V2500-D5 SERIES PROPULSION SYSTEM SERVICE BULLETIN

This document transmits the Initial Issue of Service Bulletin EV2500-75-0086

AIR - HP COMPRESSOR STAGE 10 BLEED VALVE - INTRODUCTION OF A REVISED PARKER HANNIFIN
BLEED VALVE WITH ADDITIONAL CARBON BEARING, REDESIGNED SPRING AND ADDITIONAL SPRING
GUIDE

| AIR | 10TH STAGE HIGH PRESSURE COMPRESSOR BLEED VALVE | INTRODUCTION OF 5950041-108 AND UPGRADE OF PART NUMBER (P/N) 5950041-105 AND 5950041-107 TO 5950041-108 BY INCORPORATING A NEW SPRING AND PISTON ASSEMBLY. |

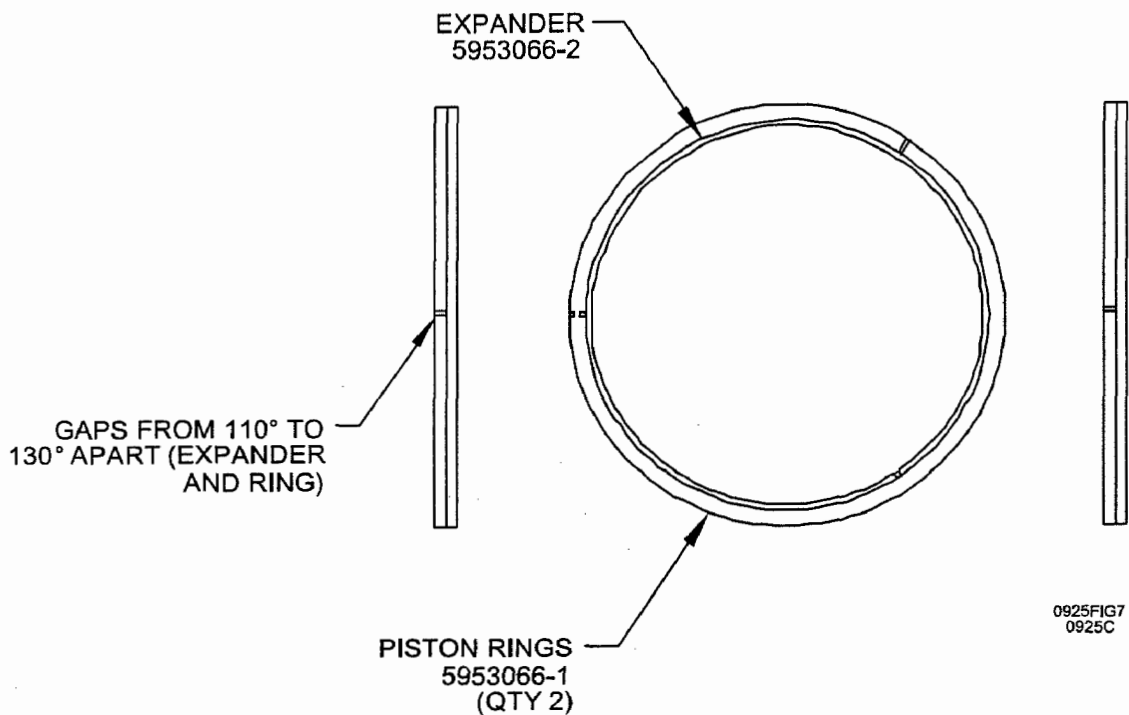
C. Assembly Procedures (See Figure 1.)

- (1) Assembly of seal assembly, P/N 5953066-101, (See Figure 2)
 - (a) Install the expander, P/N 5953066-2, into the groove of the inside diameter of the body assembly, P/N 5952018-103.

Proof Pressure Test Setup
Figure 3

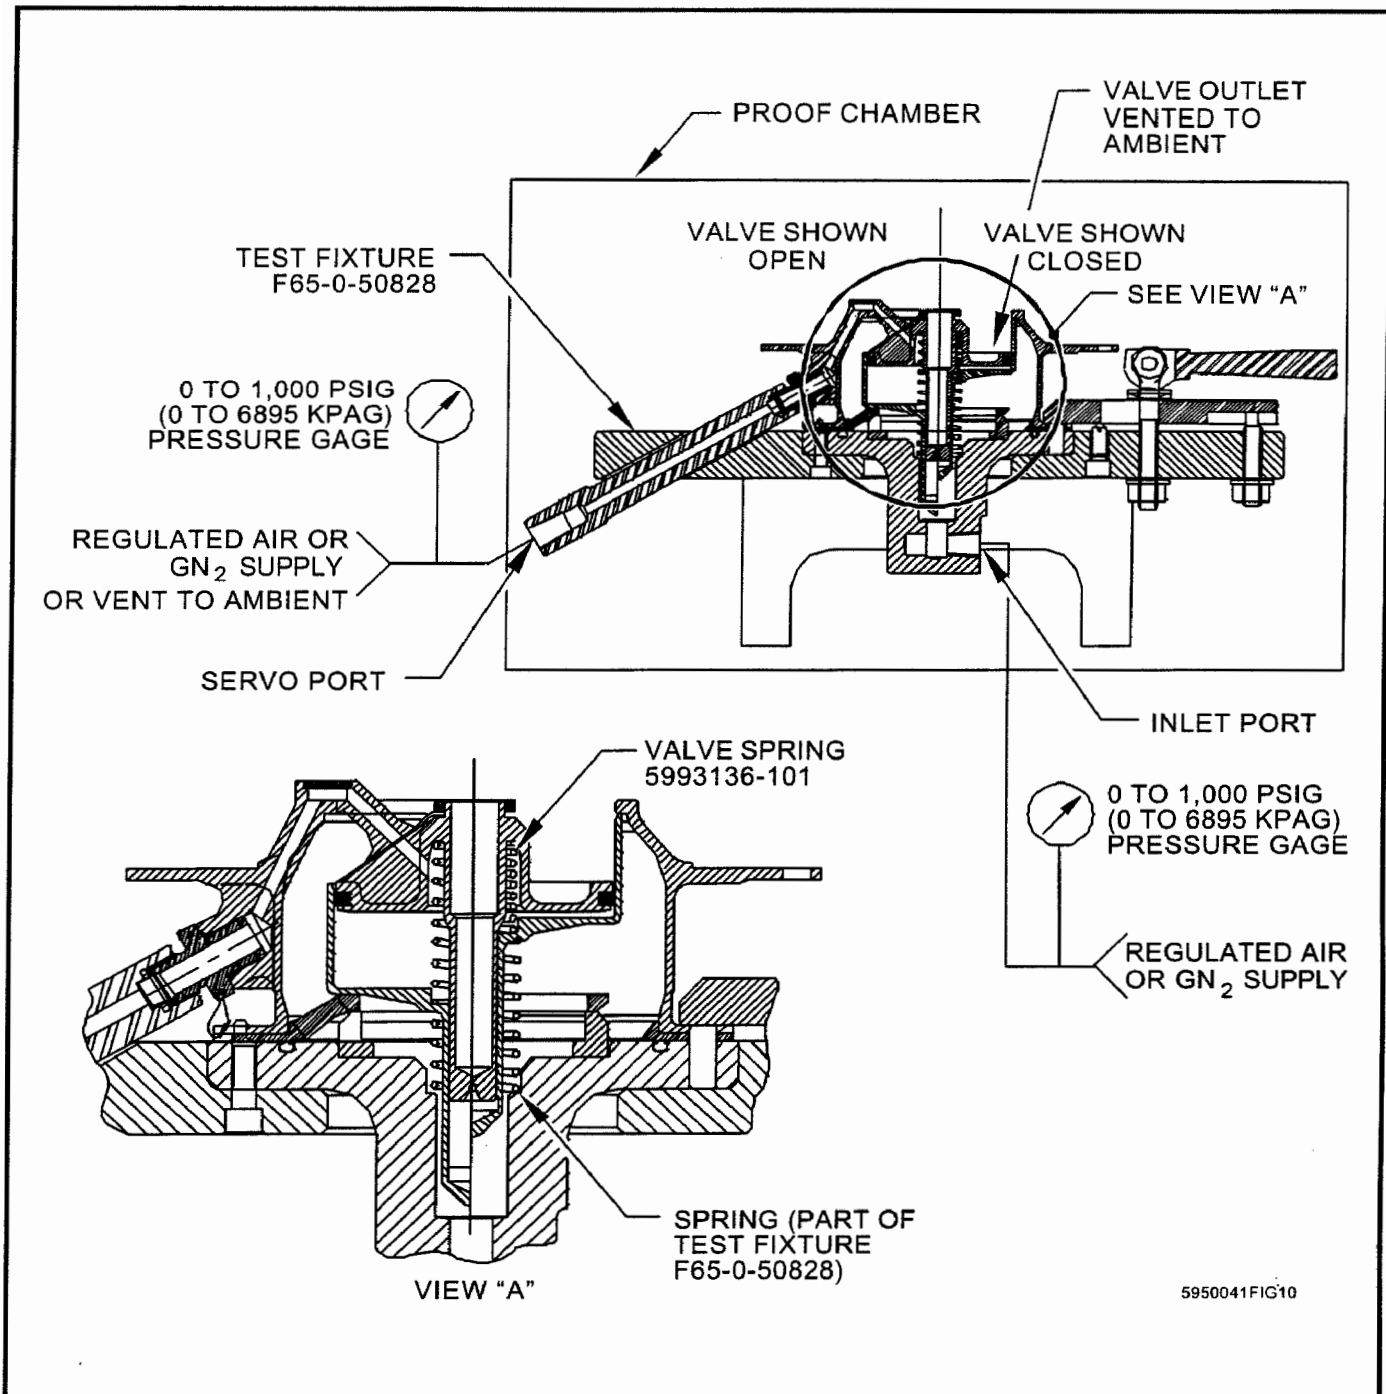
- (a) Set up the valve, as shown in Figure 3, in test fixture, F65-0-50828, and the outlet and inlet ports of the valve vented to ambient.
- (b) Slowly apply a pressure of 625 to 635 psig (4309 to 4378 kPag) to the servo port and hold the pressure for a minimum of 1 minute.
- (c) Slowly reduce the pressure to zero.
- (d) There must be no deformation or other permanent damage.

- (a) Set up the valve, as shown in Figure 3, in test fixture, F65-0-50828, and the outlet and the servo ports vented to ambient.
- (b) Slowly apply a pressure of 585 to 595 psig (4033 to 4102 kPag) to the inlet port and hold the pressure for a minimum of 1 minute.
- (c) Slowly reduce the pressure to zero.
- (d) There must be no deformation or other permanent damage.

Leakage Test Setup
Figure 4

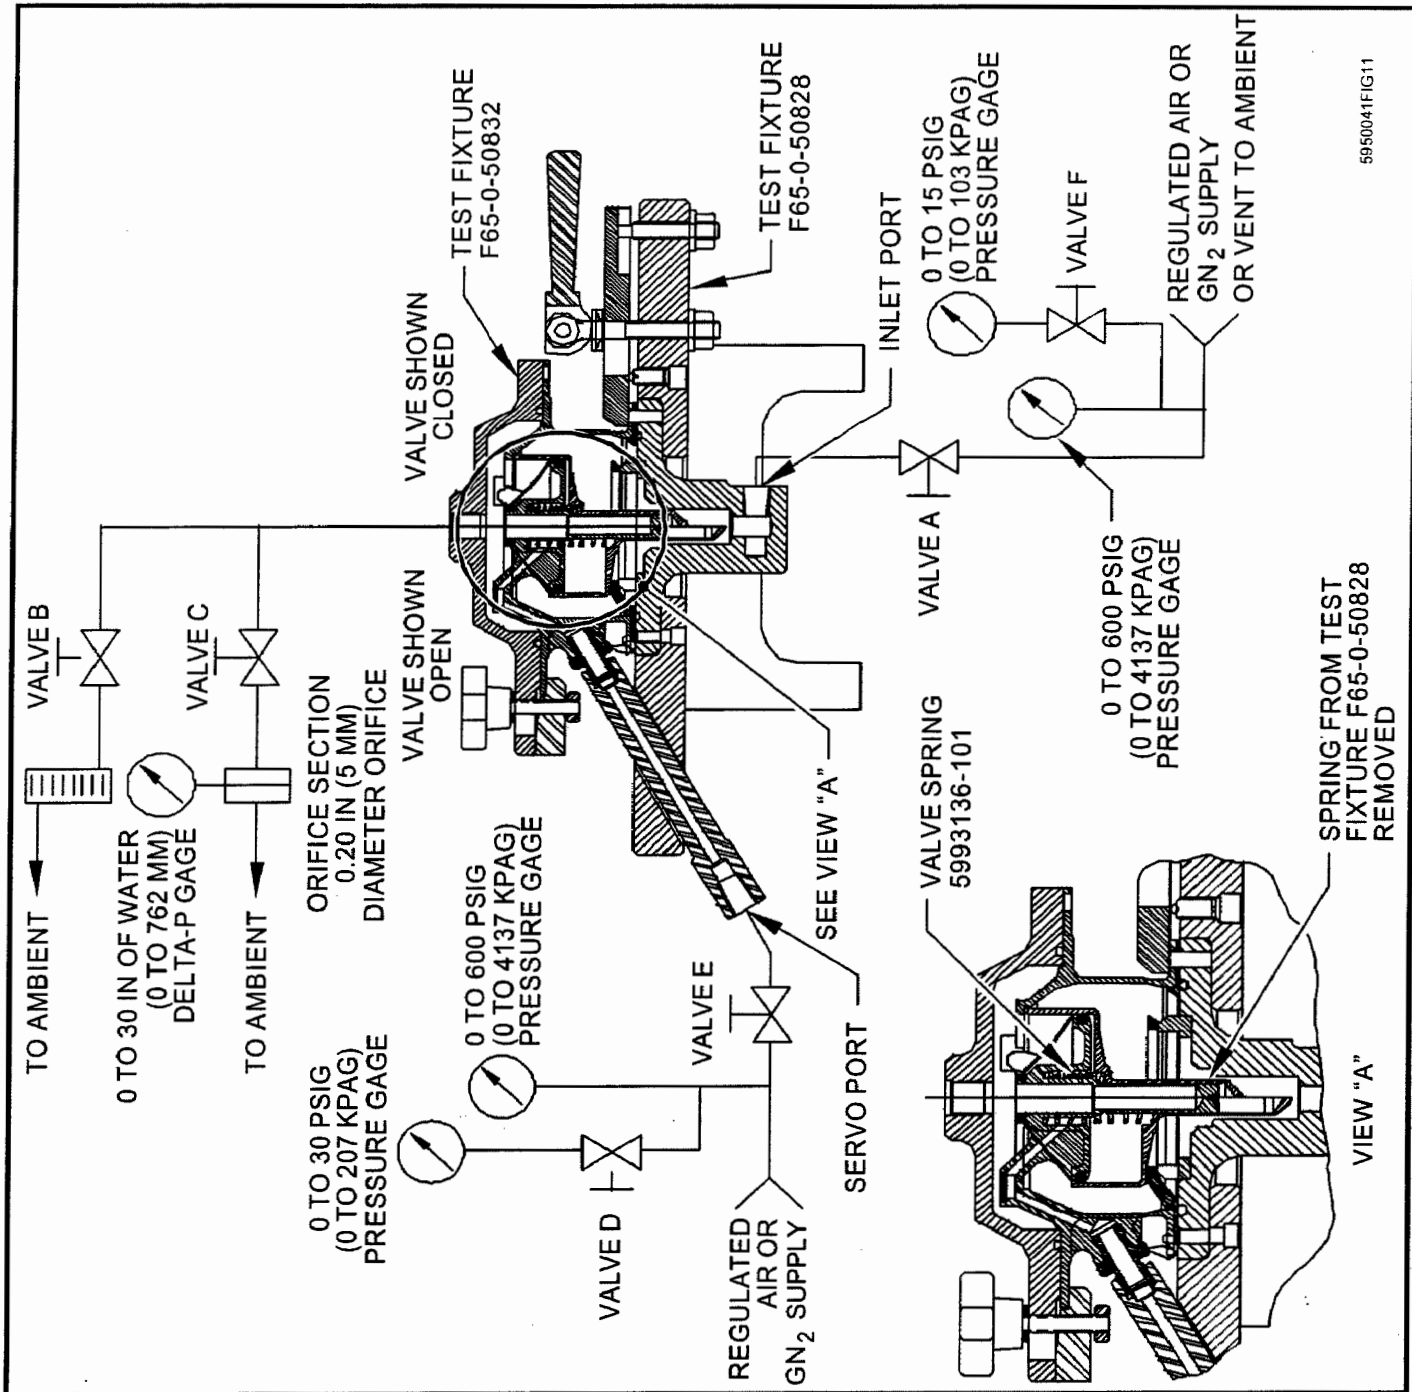
- (a) Set up the valve, as shown in Figure 4, with the spring removed from the test fixture, F65-0-50828. Close valves A and F and open valves D and E.

- (a) With the spring still removed, set up the valve in test fixture, F65-0-50828, as shown in Figure 4. Close valves D and F. Open valves A and E.
- (b) Slowly apply pressure to the inlet port until the valve closes. Close valve E.
- (c) Slowly increase the pressure to 330 to 340 psig (2275 to 2344 kPag) to the inlet port.
- (d) The leakage must not exceed 2.8 scfm (0,079 scmm) (equivalent to 0.21 lbs/minute (0.10 kg/minute)), as measured at the flowmeter.
- (e) Slowly reduce the pressure to zero.

Operating Pressures Test Setup
Figure 5

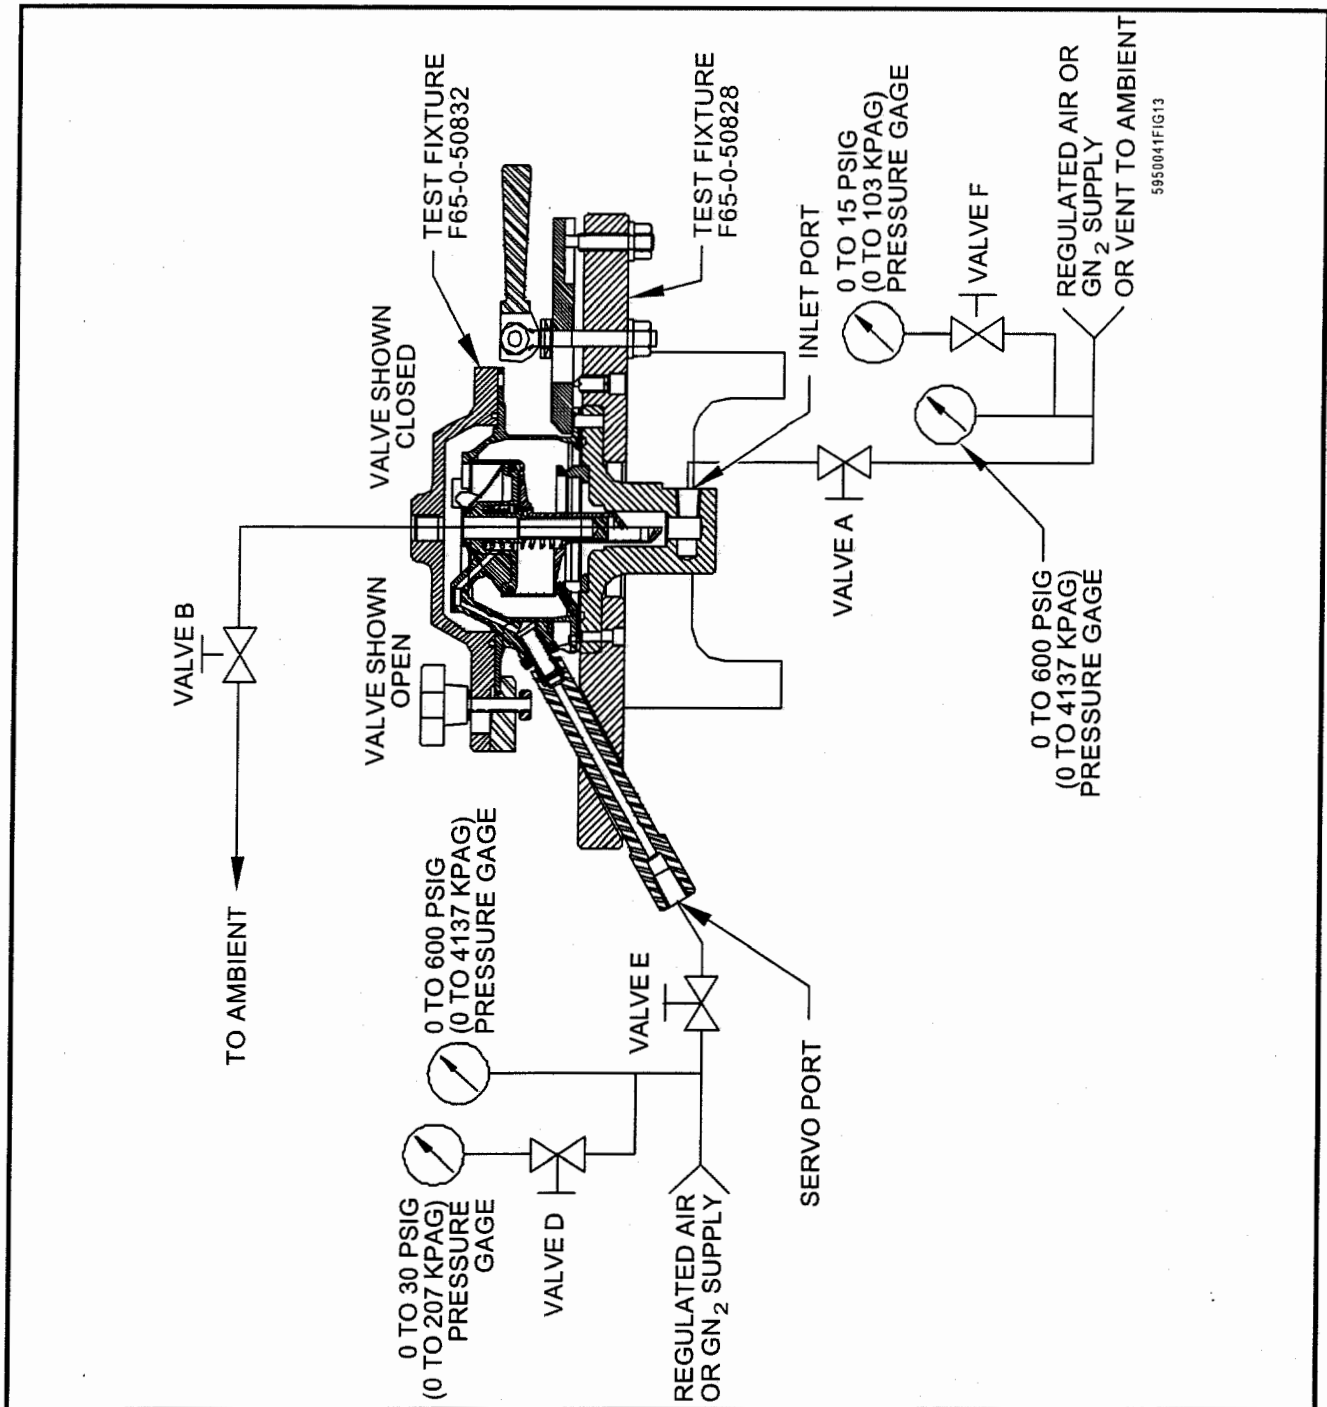
- (a) With the spring still removed, set up the valve in test fixture, F65-0-50828, as shown in Figure 5. Open valves A, D, E, and F.

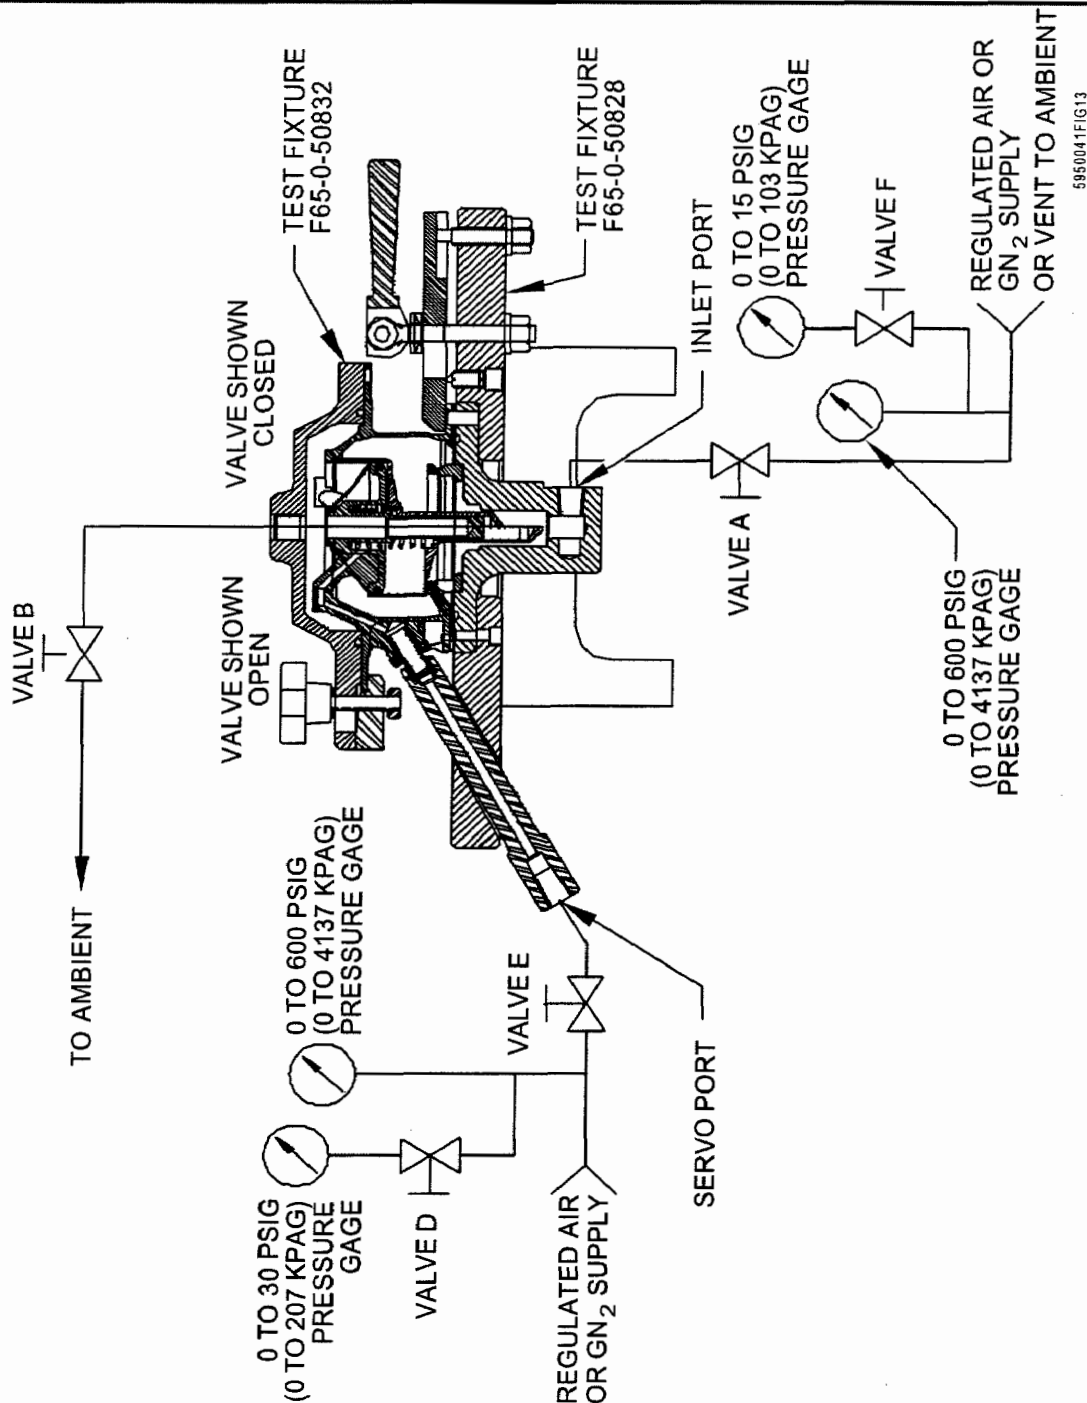
- 1 Reinstall the spring into the test fixture, F65-0-50828. Set up the valve in the test fixture, as shown in Figure 6. Close valves D and F. Open valves A and E.
- 2 With the servo pressure at zero, slowly apply an inlet pressure of 105 to 115 psig (724 to 793 kPag) to close the valve.
- 3 Slowly increase the servo pressure until the valve opens (approximately 110 to 120 psig (758 to 827 kPag)).
